Technical Bulletin 003/21

Subject: Disconnection of starter relais for transport purposes

Product: Whole Euro 5 range
Euro 4 models equipped with Lithium batteries
Euro 4 models equipped with Mobisat devices

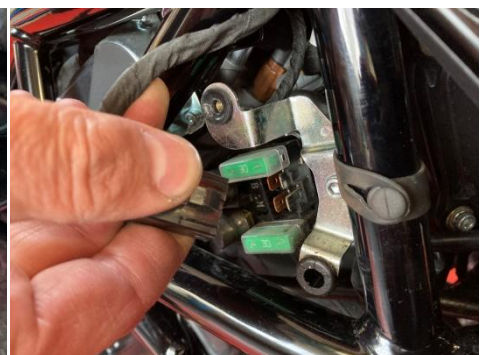
What to do	When	Why
Disconnecting the starter relais	When the motorcycle is moved with a mean of transportation (van, trailer, train, etc...)	The movements could activate the GPS tracking devices of the motorcycle and lead to the discharge of the battery

The relay can be reconnected before the next start of the motorcycle, or to allow other operations (e.g. battery recharging, etc.).
